UNITED STATES PATENT AND TRADEMARK OFFICE

APPLICATION NO.	FILING DATE	FIRST NAMED INVENTOR	ATTORNEY DOCKET NO.	CONFIRMATION NO.
09/993,698	11/27/2001	Keiichi Sakuno	0020-4933P-SP	8373

Office Action Summary

DETAILED ACTION

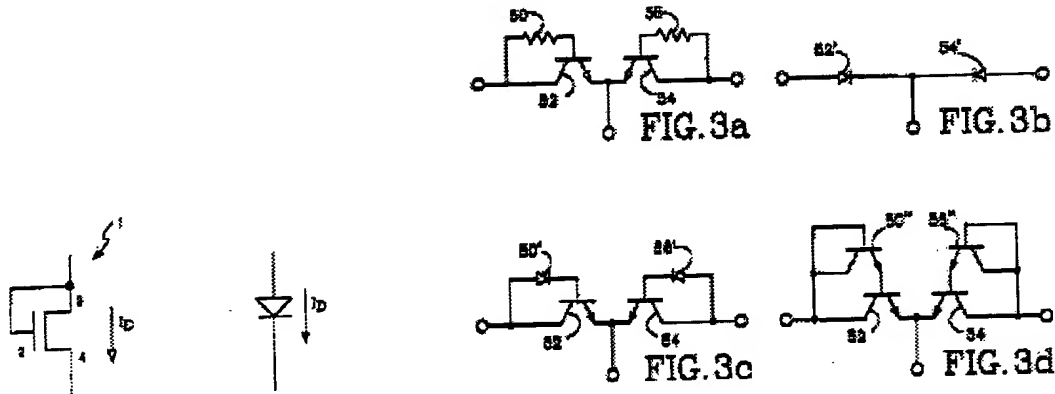
Regarding claims 6-8, Mizuno discloses the claimed invention except utilizing the diode-connected transistors (FET or bipolar). However, it is known in the art that diode and diode-connected transistor can be used interchangeably and replace one for another would be considered as a matter of design engineering. Thus, it would have been obvious to substitute diode connected transistors for the diodes of Mizuno. (See Patents 6,069,503 and 4,779,057 respectively)

Regarding claim 9, Mizuno discloses the claimed invention except the second diode has a junction area larger than the first diode. It would have been an obvious matter of design choice to substitute diode (28) with a diode having a larger junction area than the first diode (26), since such modification would have involved a mere change in size of the a component. A change in size is generally recognized as being within the level of ordinary skill in the art.
